AMENDMENT OF SOLICITATION/MODIFICATION OF CONTRACT			1. CONTRACT ID CODE	PAGE OF PAGES 1 7
2. AMENDMENT/MODIFICATION NO. 0002	3. EFFECTIVE DATE 01-Dec-2008	4. REQUISITION/PURCHASE REQ. NO.		5. PROJECT NO.(If applicable)

QUESTIONS & ANSWERS RFI # 2

**Questions & Answers
RFI # II
MeS TMC Solicitation
W917PM-09-R-0010**

APPENDIX A
SHEET A-3
Troop Medical Clinic at Mazar-e-Sharif

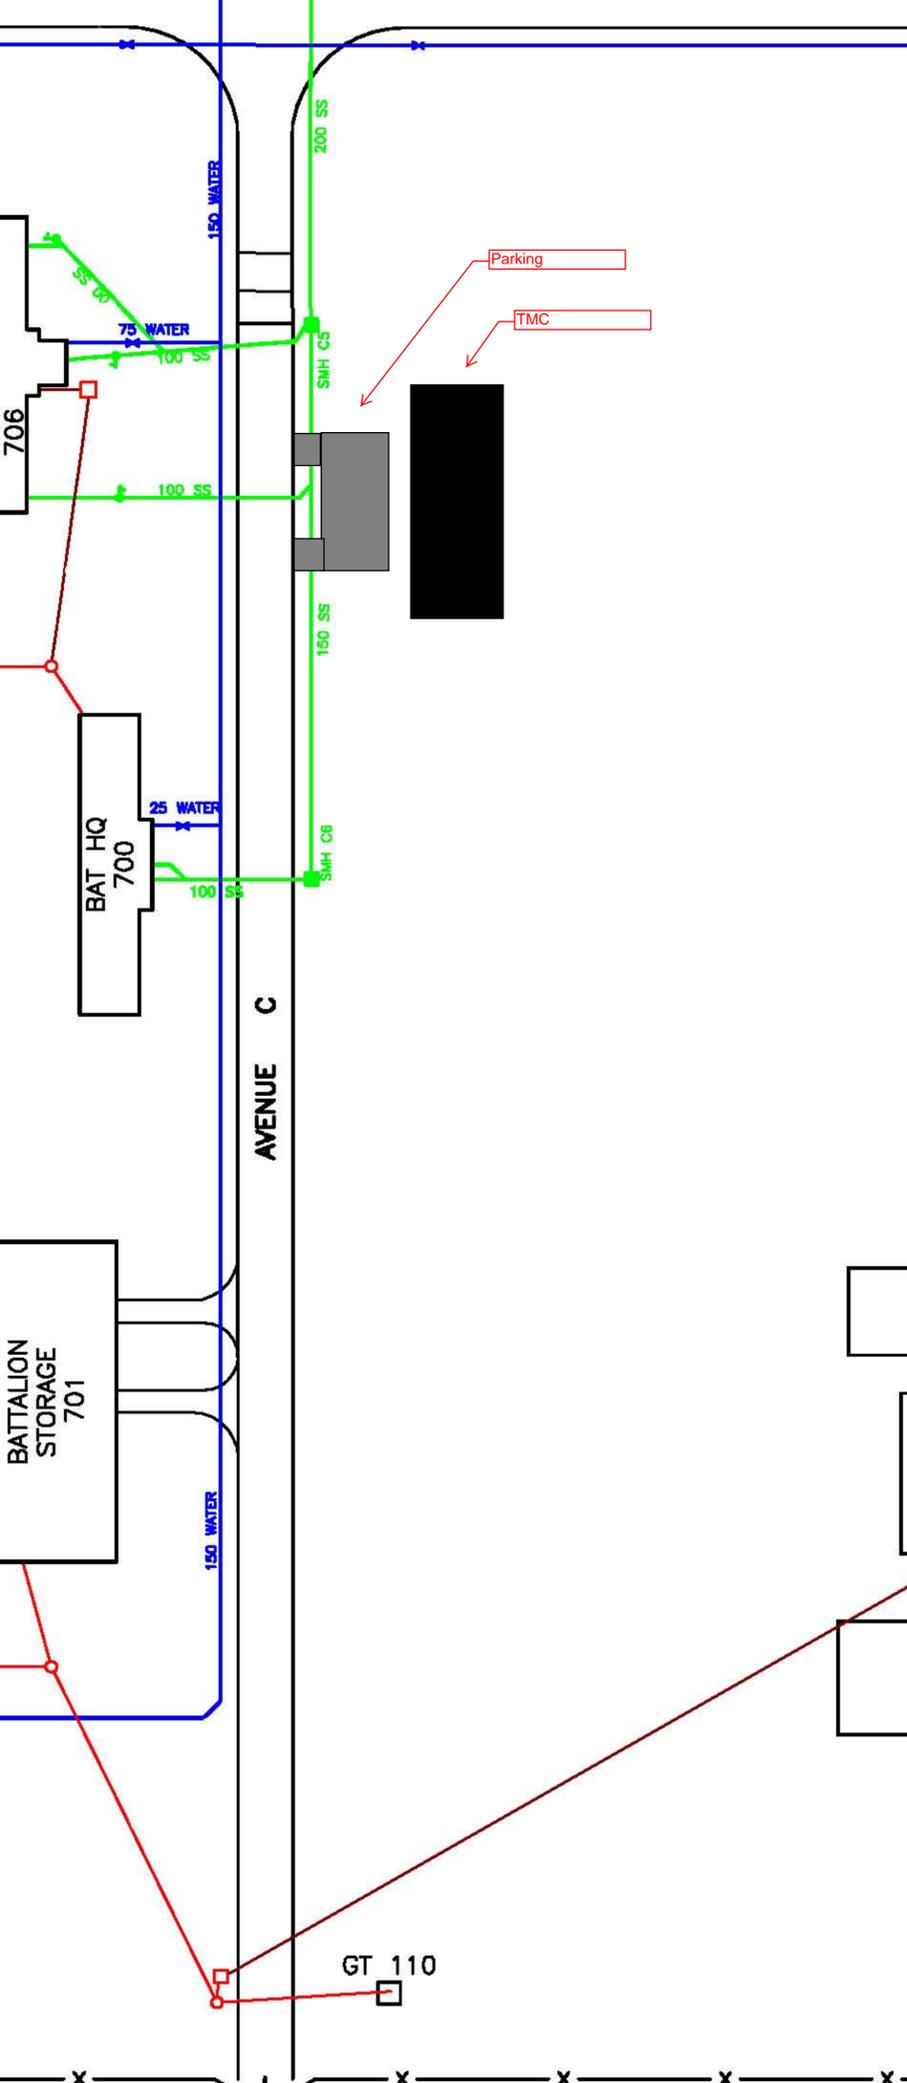
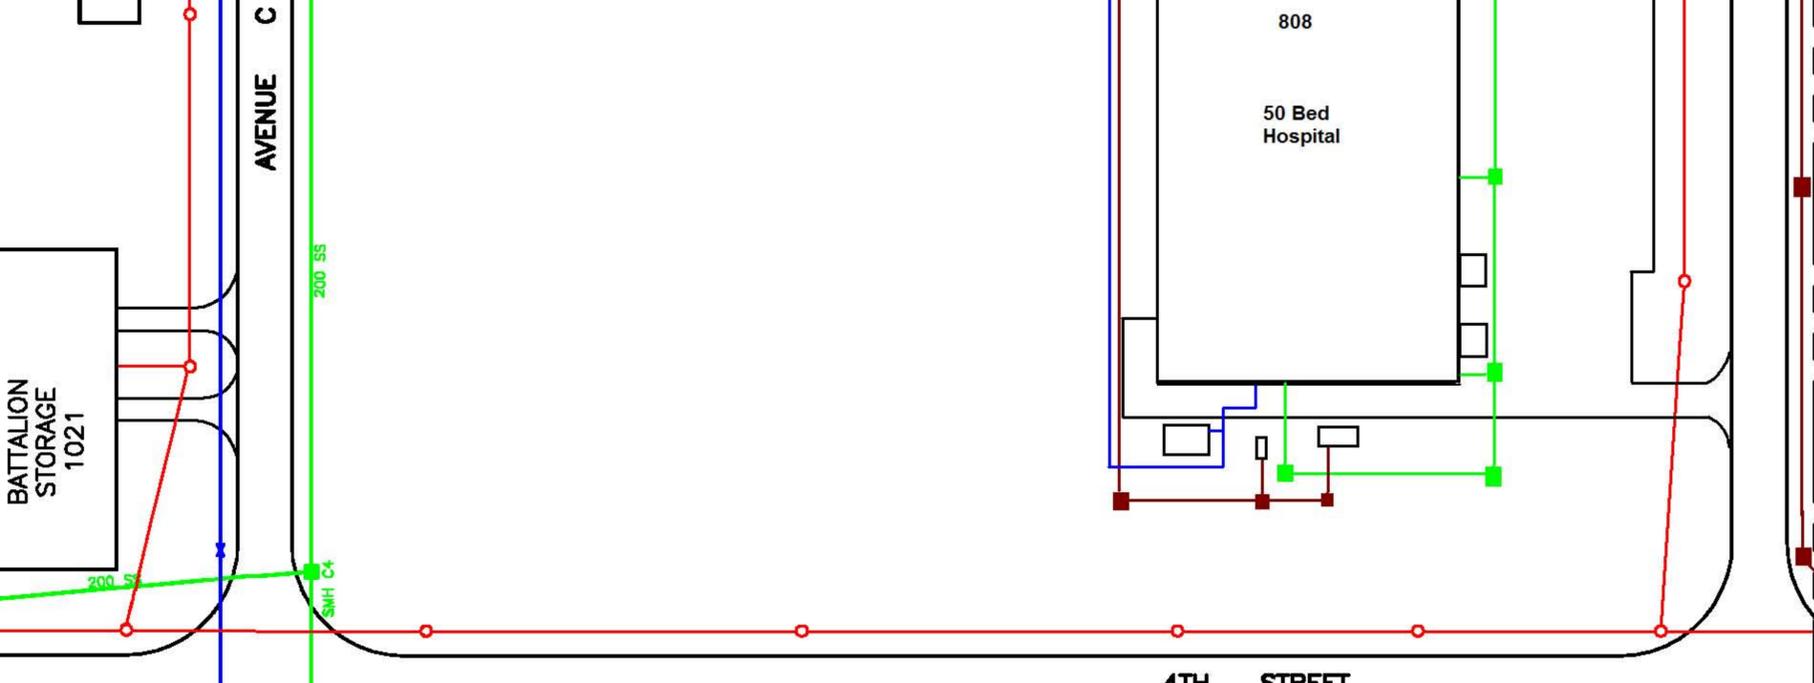
Q.5. Shall the water needed for the TMC be connected to the existing well house or the existing water network and the pressure adjusted at the TMC to prevent water hammer.

- Connect to the existing water network. Attachment A-3 shows location of the overhead electric, sewer, and water lines in proximity to the TMC site. Contractor shall design the system to achieve needed water pressure within the building while preventing water hammer.
